Submissions and Amendment Report

290-308 Aldington Road, 59-62 Abbots Road and
63 Abbots Road, Kemps Creek
Westlink Industrial Estate

Submitted to Department of Planning and
Environment

26 April 2022 | 2200446

Figure 1 The amended masterplan

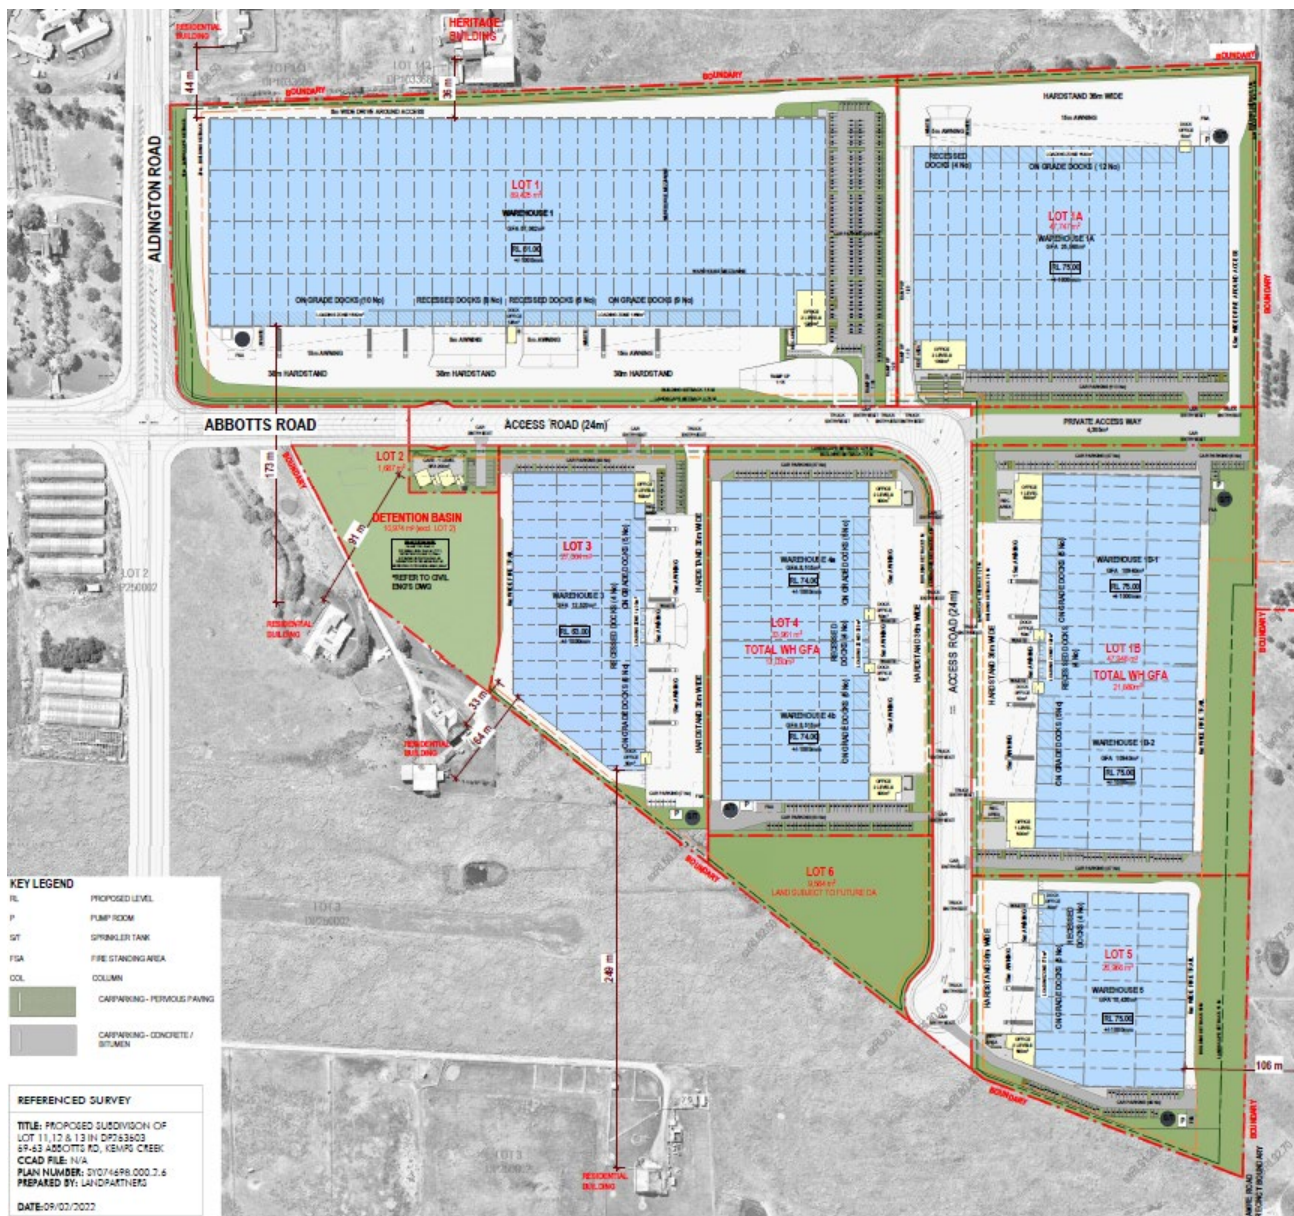
- Construction of a new internal road layout and parking for ~~777~~ **658** vehicles;
- Associated site servicing works and ancillary facilities, including OSD detention basin;

Figure 2 Proposed amended staging

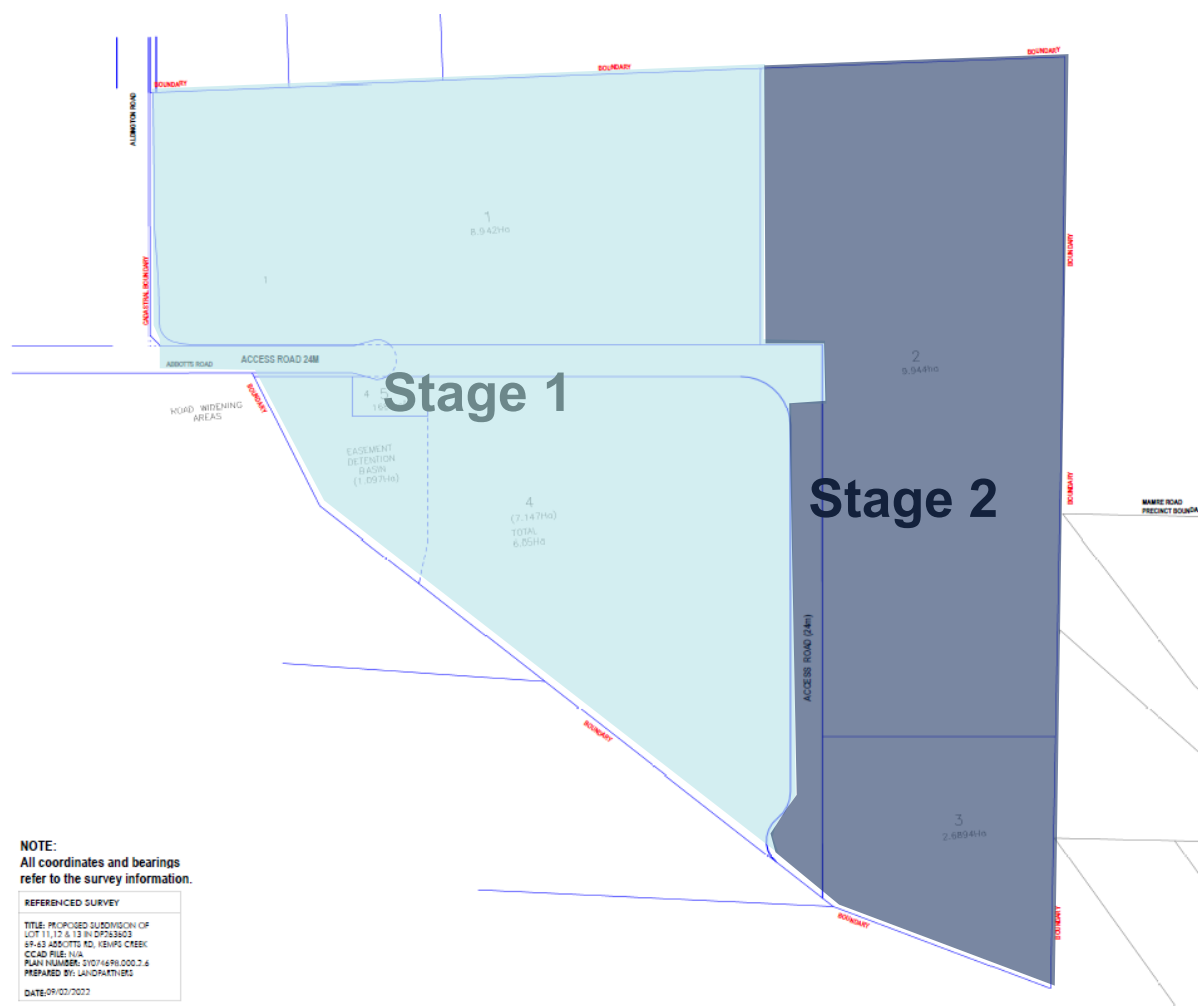
The development will now be staged across two separate stages as outlined below.

Figure 3 Proposed amended plan of subdivision

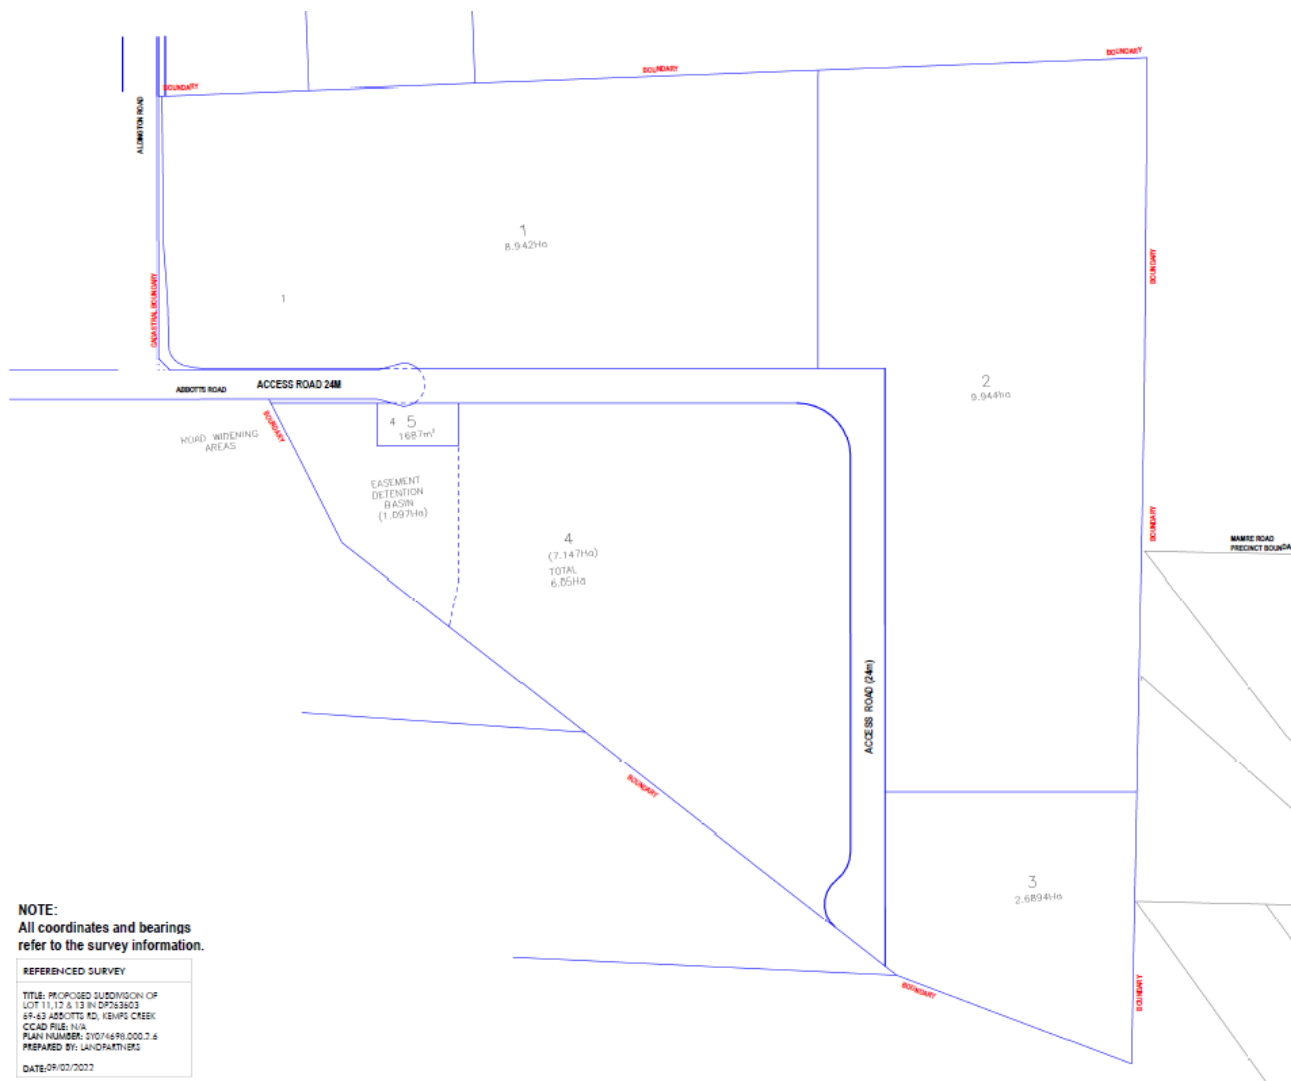
The site is now proposed to be subdivided into 5 separate allotments. Lots 1 through 4 (noting Lot 1A and Lot 1B) will comprise the new industrial warehousing buildings and their ancillary offices (with Lot 1B to contain two separate warehouse buildings) whilst Lot 5 will comprise the new café retail building. Lot 4 will also contain an easement that accommodates the proposed OSD detention basin.

The proposed subdivision works will be undertaken in accordance with the Plan of Subdivision prepared by Land Partners Surveyors at **Appendix E**, an excerpt of which is shown in **Figure 3** below.
